**Agenda Item:** 4.3  
**Source:** Nokia  
**Title:** **CR to 25.303 on RRC Connection Release Procedure**  
**Document for:** Approval

**25.303 CR 00?**

**Subject:** RRC Connection Release Procedure

### Figure 1. RRC Connection Release from Dedicated Physical Channel

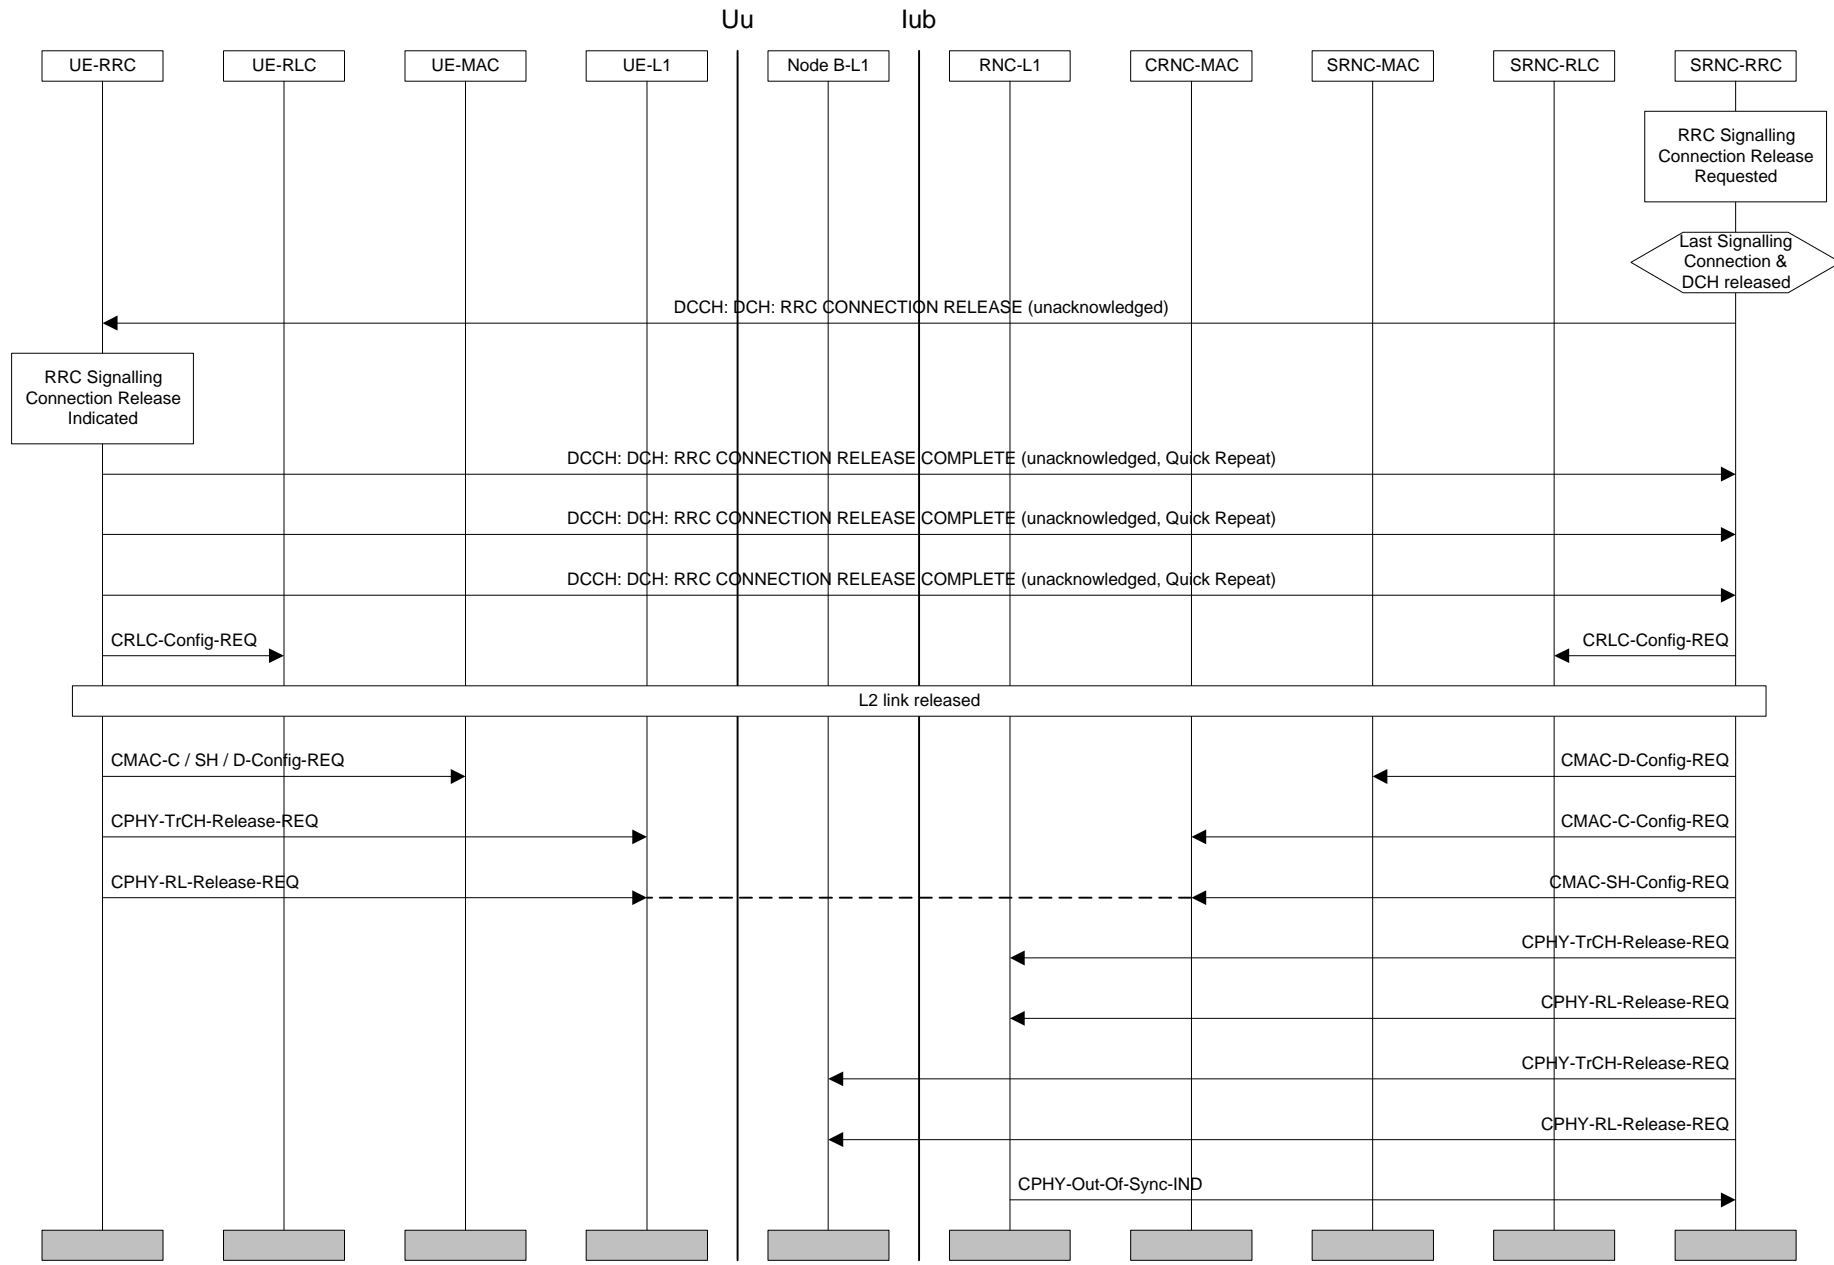
7.1.3.1: RRC Connection Release from Dedicated Physical Channel: As the procedure now includes a L3 COMPLETE-message, the RRC CONNECTION RELEASE is proposed to be transmitted in acknowledged-mode and the FFS is proposed to be removed. Same modification is proposed to the accompanying text. In the same figure the order of CMAC Config primitives has been different from the RAB release procedure. This is now aligned.

The RRC layer entity in the network issues an RRC CONNECTION RELEASE message using ~~acknowledged or~~ unacknowledged mode ~~(FFS)~~ on the DCCH. Upon reception of this message the UE-RRC sends an RRC Signalling Connection Release Indication primitive to NAS. The UE replies with an RRC CONNECTION RELEASE COMPLETE message, which is sent in unacknowledged-mode on the dedicated channel. To improve the reliability of the message, quick repeat on RRC-level can be used. The UE will then proceed to release RLC(s), MAC and the radio link(s) after which the UE RRC enters Idle Mode.

**Figure 2: RRC Connection Release without Dedicated Physical Channel**

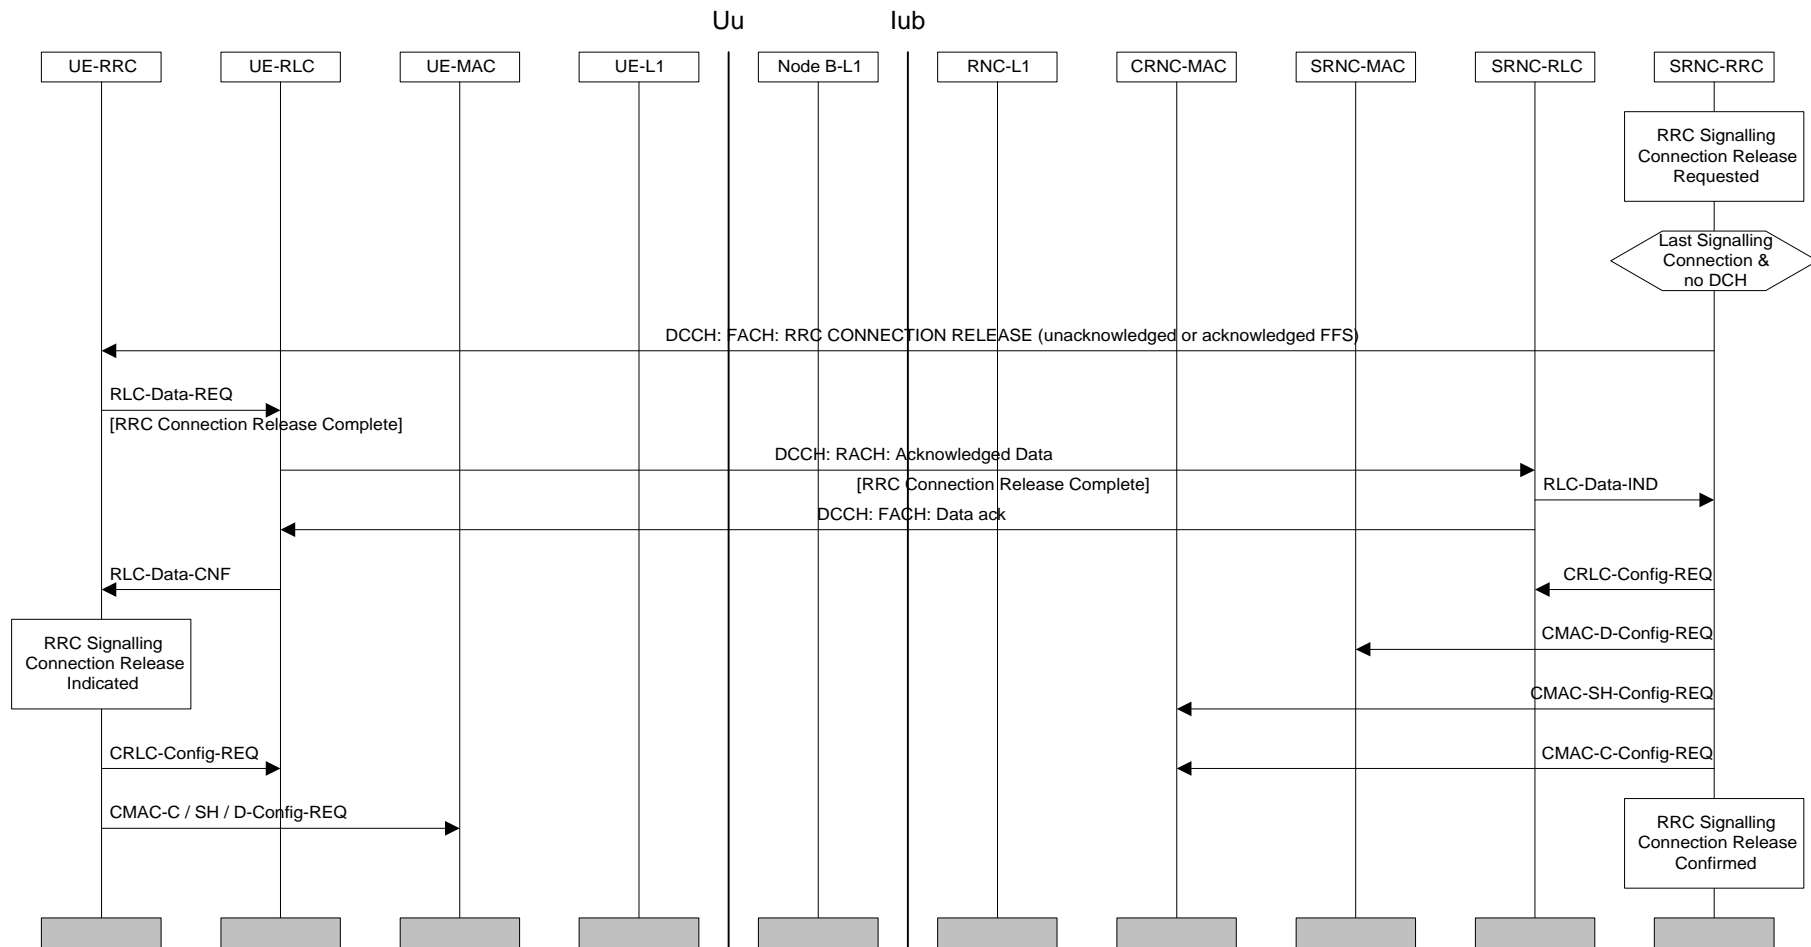
7.1.3.2: RRC Connection Release from Dedicated Physical Channel: A mismatch between the figure and the text is corrected and a note is moved to a new position.

The RRC layer entity in the network issues an RRC CONNECTION RELEASE message using unacknowledged ~~or acknowledged~~ mode on the DCCH. Upon reception of this message the UE-RRC sends an RRC Signalling Connection Release Indication primitive to NAS and an RRC CONNECTION RELEASE COMPLETE message to UTRAN using acknowledged mode on the DCCH.

[Note: Depending on RLC design, the acknowledgement to RRC CONNECTION RELEASE could be piggybacked to the RRC CONNECTION RELEASE COMPLETE MESSAGE, resulting in no additional messages. Therefore acked / unacked transmission is considered FFS.]

~~[Note: Depending on RLC design, the acknowledgement to RRC CONNECTION RELEASE could be piggybacked to the RRC CONNECTION RELEASE COMPLETE MESSAGE, resulting in no additional messages. Therefore acked / unacked transmission is considered FFS.]~~
